Author Details	
Name	Dr Andrew Boswell
Position	Independent Scientist & Consultant
NZT Registration	20029943
Organisation	Climate Emergency Policy and Planning (CEPP)
Examination Principle Issues	<ul style="list-style-type: none"> • Full lifecycle Greenhouse Gas (GHG) emissions • Cumulative assessment of GHG emissions • Air Quality • Scope of Development and Environmental Impact Assessment

POST EXAMINATION CONSULTATION – 19th JANUARY 2024

1.1 Post Examination Consultation – December 20th 2023 letter

UK gas supply mix and carbon dioxide emissions

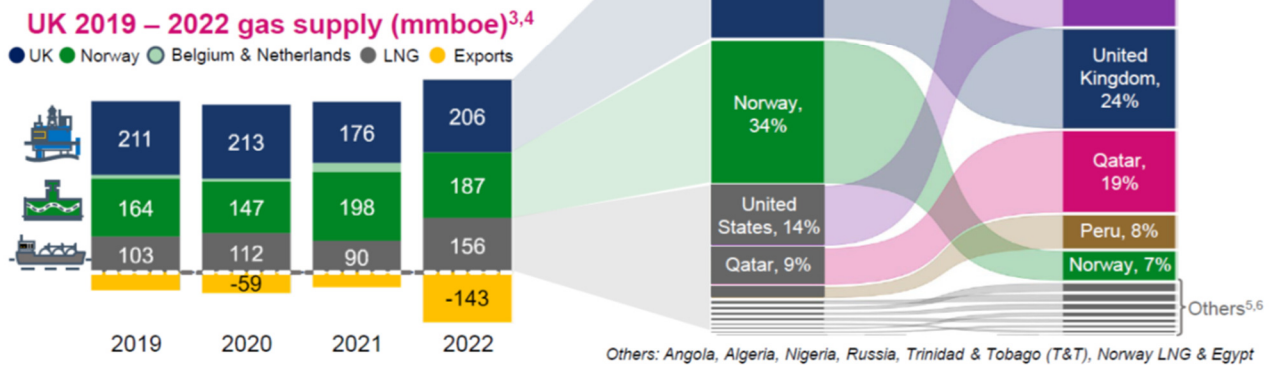
41 I now discuss point (3) above further. First, I reproduce part of the factsheet:

In 2022, gas imports to the UK accounted for 63% of its natural gas supply. The UK helped to meet the surge in European LNG demand by increasing its LNG imports (by 74%) and then exporting the surplus supply to Europe through pipelines (240% increase from 2021).

42 The left of the picture gives gross supplies of UK gas supply by three overall categories: Domestic supply, pipeline import (largely Norway) and LNG (largely US and Qatar). From this is possible to simply calculate the percentage of UK methane (natural gas) supply between the years 2019 and 2022. This is shown in rows A, B and C at Table 3 below¹⁰.

43 Then it is possible to calculate an aggregated carbon intensity of the UK gas supply using the figures on the data sheet of 21 kgCO₂/boe for UK domestic supply, 8 kgCO₂/boe for pipeline imports, and 79 kgCO₂/boe for LNG – this is shown in row D. Then it is possible to work out its percentage against the 2020 data as 100%. 2020 has been chosen for this percentage as the data for 2019 appears to be out of kilter¹¹. This percentage is given at row E below.

44 Then the “WTT Fuels” Scope 3 factor from the DESNZ emission factors for “Natural Gas” [“Total kg CO₂e per unit” for “kWh (Net CV)”] is given in row F. Finally, I work out its percentage against the 2020 data as 100% (given in row G below).

45 If the BEIS/DESNZ data reflected the proportions of UK domestic, pipeline import and LNG supply given by the NSTA factsheet, then the percentages in rows E and G would be expected to be relatively similar and follow the same trend. They are not and do not.

46 For example, the aggregated carbon intensity based on NSTA is 107.6% above its 2020 value whereas the BEIS/DESNZ “WTT Fuels” Scope 3 factor against 2020 is 96.3% of its 2020 value.

47 From this, I conclude in response to my point (3) concern above that the BEIS/DESNZ “Natural Gas” “WTT Fuels” Scope 3 factors do not reflect reality on the ground as reported by NSTA over the years 2020-2022. And, in the case of the 2022 data (as reported in 2023), the DESNZ Scope 3 factor significantly under-represents the aggregated real-world carbon intensity. The 2023 WTT factor for natural gas is around 3% lower than the corresponding factor for 2022, (as above), whilst according the NSTA factsheet, the aggregated carbon intensity went up by 24% [(107.6%/86.9%) - 100% = 23.8%].
